## **SECTION 4.56 APPLICATION TO AMEND DA-826/2020 | 149-163 MILTON STREET, ASHBURY**

This letter has been prepared by Urbis Ltd on behalf of Ashbury Projects Pty Ltd (the Applicant) in support of a section 4.56 application to modify DA-826/2020 pertaining to land at 149-163 Milton Street, Ashbury (the site).

Figure 3 Approved and Proposed Ground Floor Plan

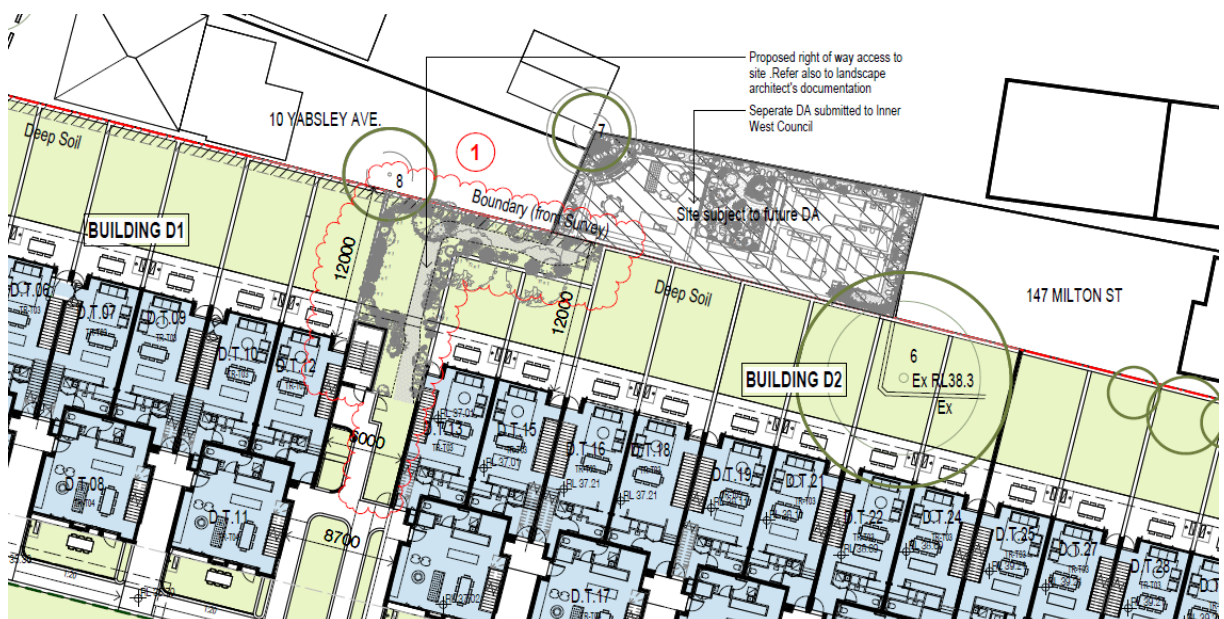
- Construction of a new lockable gate and landscaped private footpath between Building D1 and Building D2 to provide access to the proposed single-storey dwelling. This will be facilitated through the creation of a right of way easement benefiting Lot 1 DP 205503.
- Minor external changes to the rear gardens of Units D.T.13 and D.T.15 to accommodate the proposed pathway.
- Extension of existing stormwater infrastructure within the site and connection to stormwater infrastructure within Lot 1 DP 205503 to allow for the servicing of the proposed dwelling. This will be facilitated through the creation of a drainage easement benefiting Lot 1 DP 205503.
- Allocation of parking space 125 to the residential dwelling.

Figure 4 Approved and Proposed Deep Soil

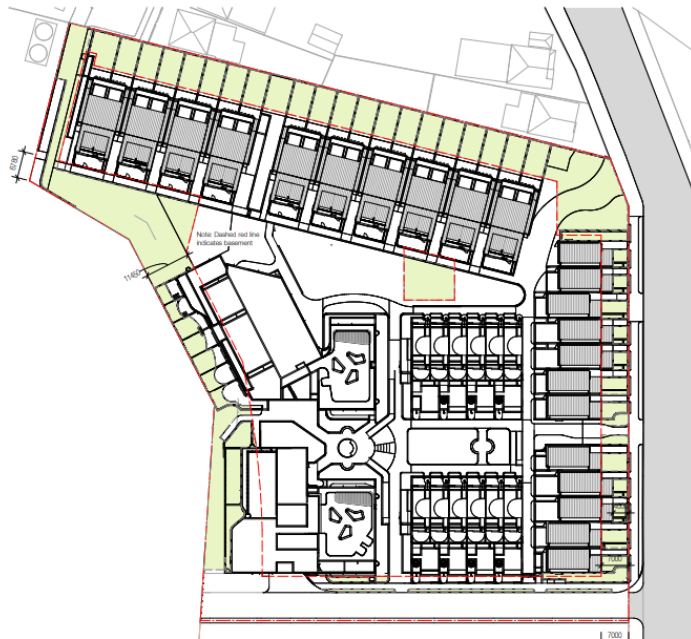
The proposal seeks to construct a new landscaped pedestrian access pathway between the terraces in Block D, traversing behind .D.T.13 and D.T.15. The proposed deep soil area of 18% remains well in excess of that required under the DCP.

Additionally, the purpose of this modification is to facilitate access to the adjoining site at Lot 1 DP 205503 which is proposed to be developed to accommodate a single dwelling. As such, the reduction of deep soil within the subject site will be immediately offset by the increase in deep soil on the adjoining site, given that the adjoining site currently accommodates a hardstand area.
